DRAWING NO.
SUI896-WI02

NAME HERMETIC UNIT ASSEMBLY

TECUMSEH PRODUCTS CO.
ANN ARBOR, MICHIGAN

DRAWING NO. SUI896-WI02

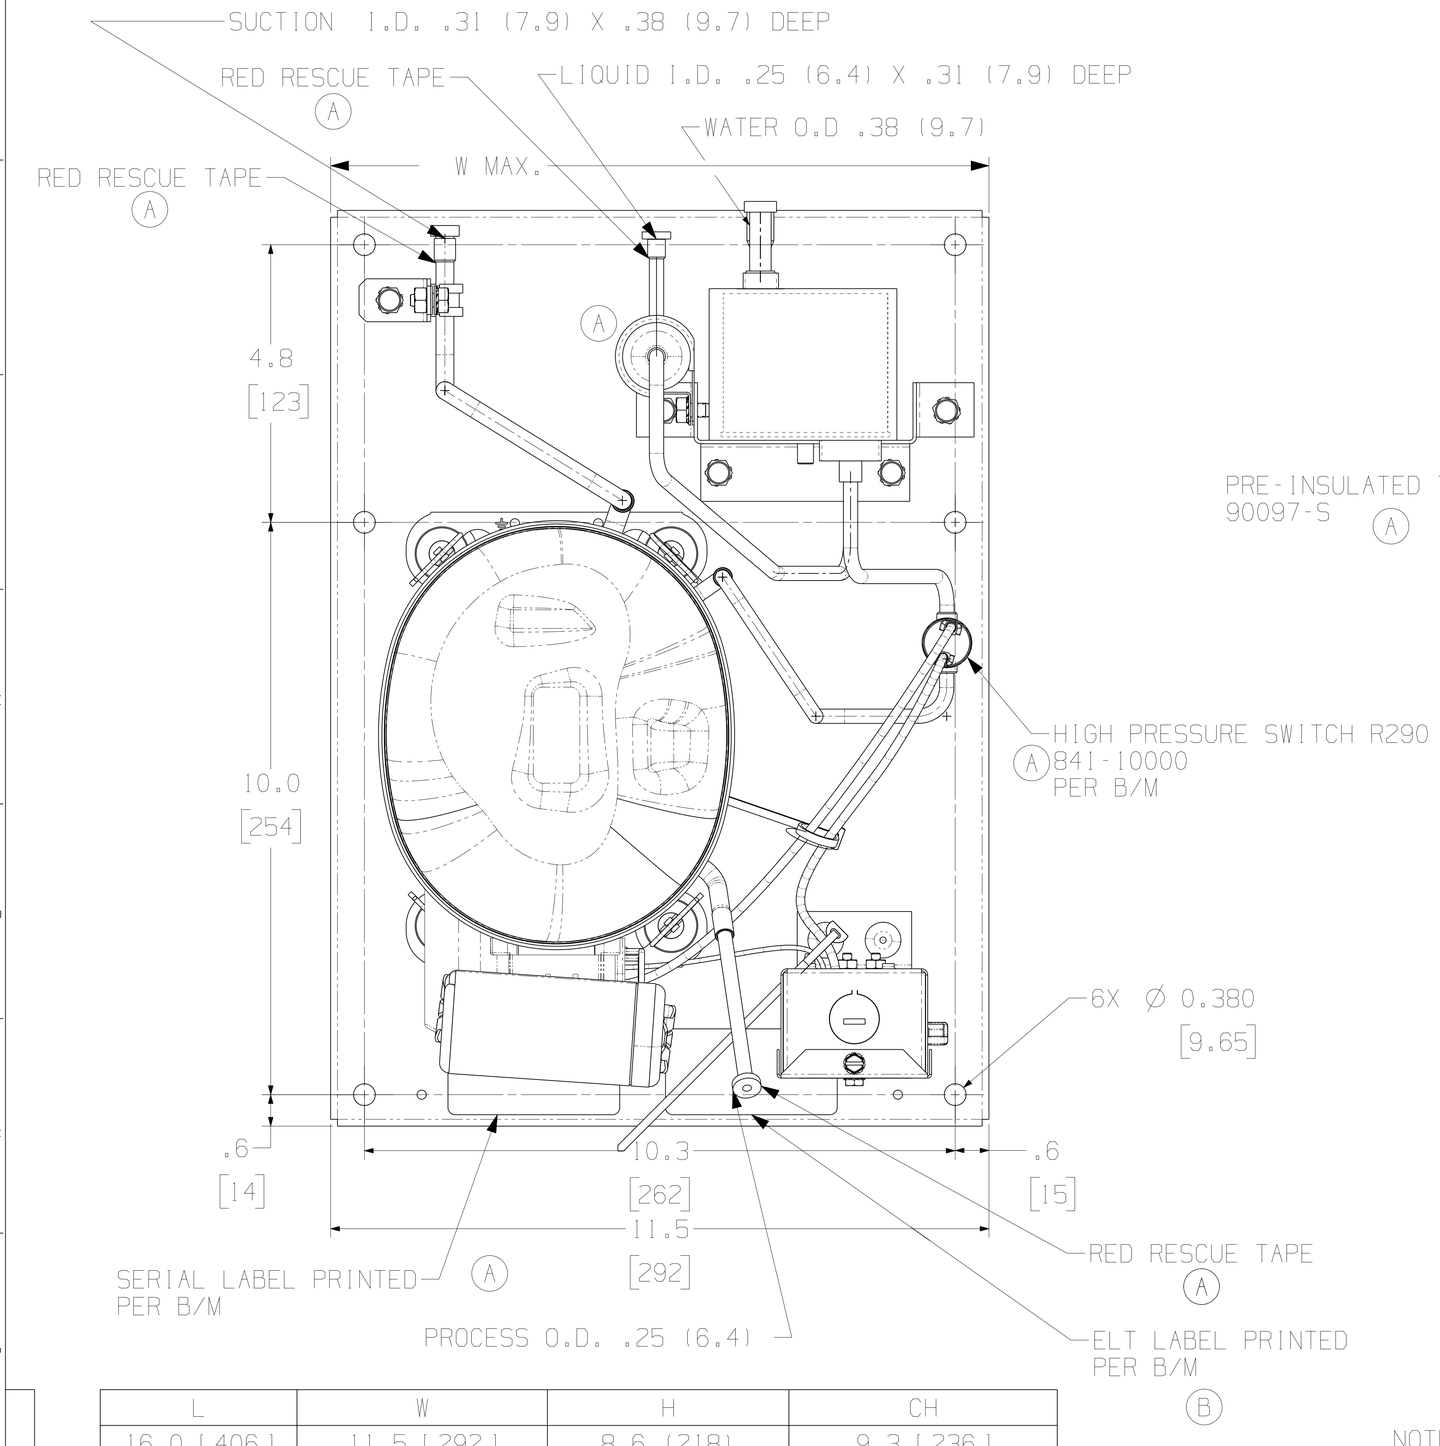
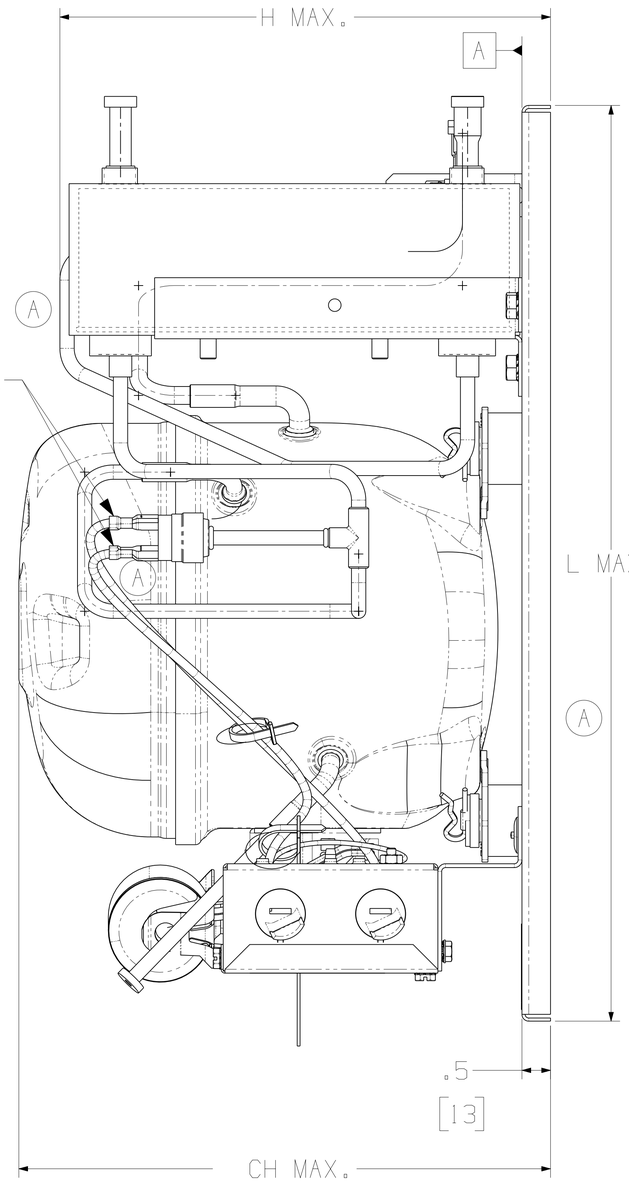
REL	LT	LC	CHANGE	DATE
B	B7	G10	EC51031 ADDED ELT LABEL 15MAR13 / INSULATION AROUND LIQUID FILTER REMOVED	15
		F5	INSULATION AROUND SUCTION ADDED	
		D3	SCREENED GROUP REMOVED	
		D8	PRESSURE SWITCH R290, 841-10000 REPLACES PRESSURE SWITCH R404	17JAN13 BD
A		--	RED RESCUE TAPE ADDED	
		F6	PRE INSULATED TERMINALS ADDED 90097-S	
		E5	WIRES ADJUSTED FOR NEW SWITCH	
		B10	SERIAL LABEL REMOVED	
--	--	--	EC47343	----
